Addendum 2
File 17-0472
Project: Clyde Connector Trail Restoration

This addendum serves to notify all bidders of the following changes to the solicitation documents:

3
3 STONE RETAINING WALL - LOWER SIDE WHERE DAYLIGHT SLOPES EXCEED 1:2
NO SCALE

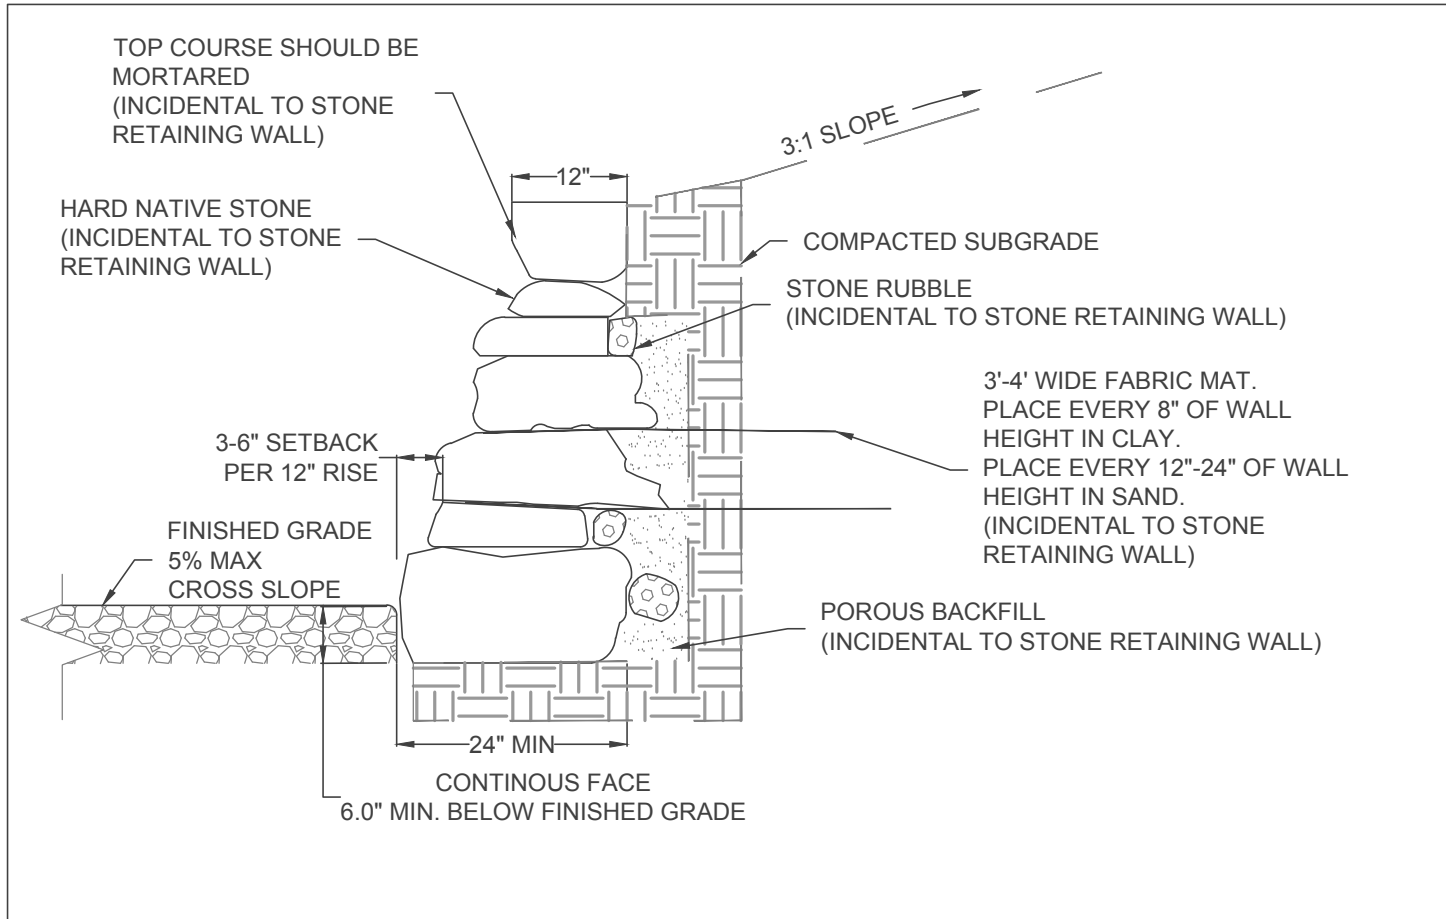
6. Details 2/3 and 3/3 showing the construction of stone retaining walls along the Clyde Trail have been revised. The intent of the details is to illustrate the use of natural stone, obtained from grading work on the project site, to create small stone retaining walls and armoring. The nature of the work would be for the Contractor to salvage larger stone suitable for creating these walls from the common excavation materials encountered onsite. The use of these walls is to provide support for the edges of the trail base and protection against erosion. The work shall be paid for as

Stone Retaining Wall (SY) as measured in the field.

| CLYDE CONNECTOR TRAIL LAYOUT | |

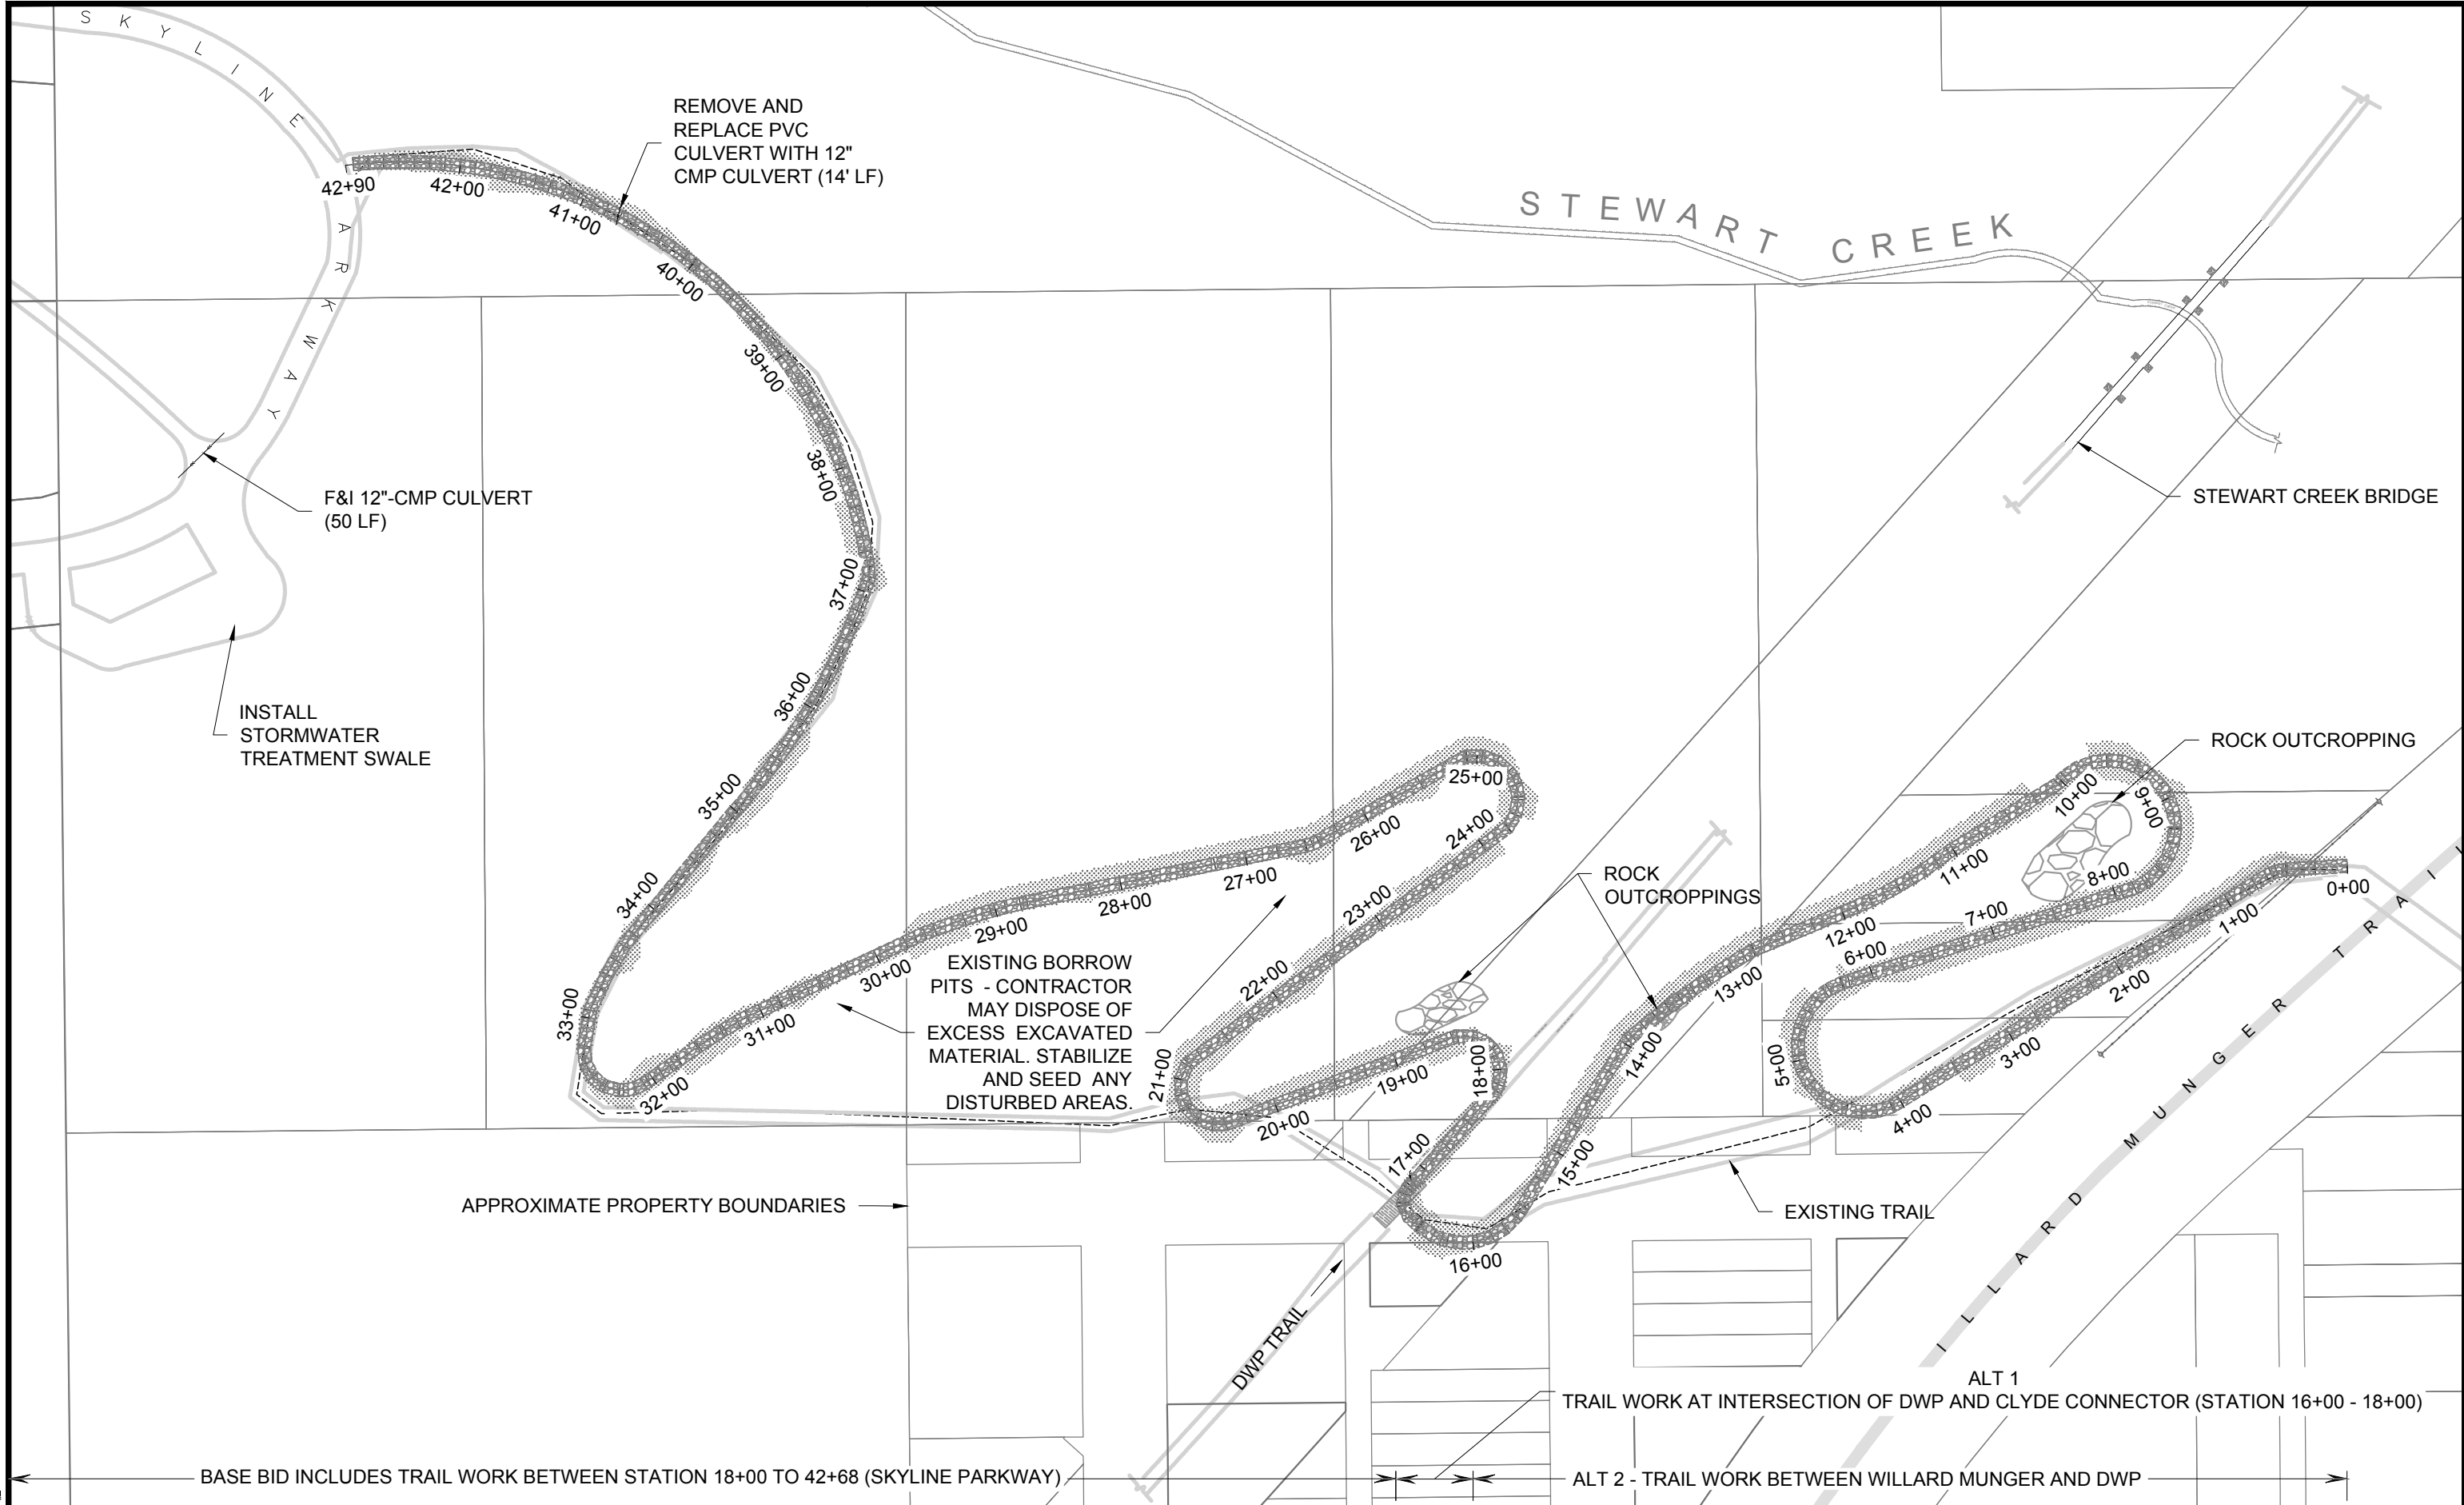
4. To mitigate tree removal near the Skyline parking lot, the trail will stay on existing alignment from station 37+00 to the top end, Station 42+68 instead of moving west to lessen grade.

7. Two 12-inch diameter CMP culverts have been added to the project work per the SEQ on Sheet 2 of the Plan and as shown at the locations noted on Sheet 4 of the Plans.

8. Obscure and Revegetate Existing Trail pay item is provided for work done to obscure and remove existing trail grade from use between Stations 32+00 to 21+ 00 and 20+00 to 17+00 as shown on the layout on Sheet 4 of the Plans. Because the trail is being extended in length and on a new alignment to improve grades for trail users, the old alignment needs to be removed from public use. This can be accomplished by placing extra common excavation over these areas, seeding, and placement of scattered boulders to discourage use by the public and to foster growth of plants to cover the old alignment. Seed mix used to re-vegetate these areas should be the Mixture 36-311. All materials, labor, and equipment necessary to accomplish this work shall be paid for under this pay item.
